METROPOLITAN GOVERNMENT OF NASHVILLE AND DAVIDSON COUNTY

STAFF RECOMMENDATION
Neighborhood Conservation Zoning Overlays
September 18, 2019

Project: Neighborhood Conservation Zoning Overlay Consolidation Project
Project Lead: robin.zeigler@nashville.gov

Figure 1: This image appears in all the NCZO design guidelines. *The caption reads: Image to the right shows the area in which new construction would not require a Preservation Permit. All construction outside of the area will be reviewed.*

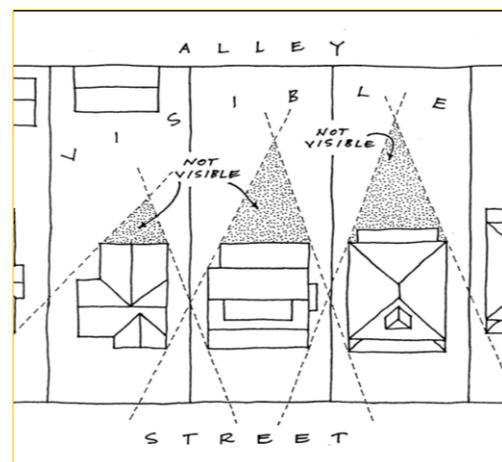
The drawing shown in Figure 1 is currently in all the neighborhood conservation zoning design guidelines. It is often read as showing the only place where an addition can be constructed, which is not the case. Instead it is meant to show that if an addition is small enough to fit into that triangular area, then the addition would not need to be reviewed.

A related concern is that the text portion of the design guidelines, which attempts to state what is reviewed, is confusing in that one section states that the design guidelines only apply to areas that are visible from the public right-of-way and the next section states that public facades are more carefully reviewed than others. Since the establishment of the first overlay, the Commission has interpreted these sections as a review of all sides of any new construction but

applying a less stringent review of those facades that are not publicly visible.

The proposed solution to the image and the text is to remove the image (Figure 1) and replace it with a list of actions that would not require review. Removing the image is not likely to cause a hardship for applicants as the Commission only receives 1 or 2 requests a year for additions that would meet the conditions of Figure 1. By the time staff gathers enough information to determine a review is not needed, staff has enough information to just go ahead and issue the permit. Permits for small additions typically have been issued, and will continue to be issued, within a few days. We also recommend clarifying the text to meet the interpretation of the last several decades.
